# Recall Bulletin

**SUBJECT:** Accelerator Pedal Sticking

**MODELS:** 2009-2010 Pontiac Vibe

**(1) Feeler Gauge (C) Clearance (2) Stopper (4) Housing**

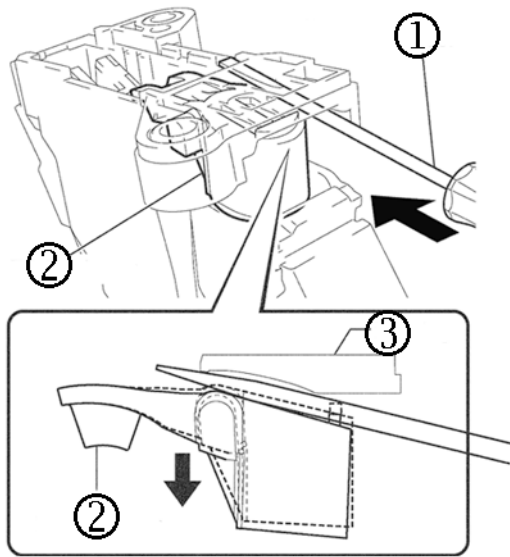
The Service Procedure, Step 6.3, has been revised to remove the requirement to call the Technical Assistance Center if the clearance between the stopper and housing is greater than 2.70 mm. If the clearance is greater than 2.70 mm, dealers are to replace the pedal. The part number for the pedal has been added to the Parts Information section and a new labor code has been added. Step 12 in the Service Procedure has also been revised to remove programming instructions that are no longer applicable. Please discard all copies of bulletin 10018B, issued February 2010.

- 6.1. Using a feeler gauge (1), measure the clearance (C) between the stopper (2) and the housing (4).
- 6.2. Only insert the feeler gauge 10 mm from the end of the housing as illustrated.
- 6.3. Based on the measurement from Step 6.1, select the correct reinforcement bar using the table below.

Clearance	Reinforcement Bar	
	Thickness	Stamping
0.0 mm – 0.29 mm	1.4 mm	1.4 A
0.3 mm – 0.59 mm	1.6 mm	1.6 B
0.6 mm – 0.79 mm	1.8 mm	1.8 C
0.8 mm – 1.09 mm	2.0 mm	2.0 D
1.1 mm – 1.49 mm	2.3 mm	2.3 E
1.5 mm – 1.89 mm	2.6 mm	2.6 F
1.9 mm – 2.70 mm	2.9 mm	2.9 G
greater than 2.70 mm	Install a new accelerator pedal, P/N 19205346. This pedal does not require a shim or pedal length modification. Discard old accelerator pedal.
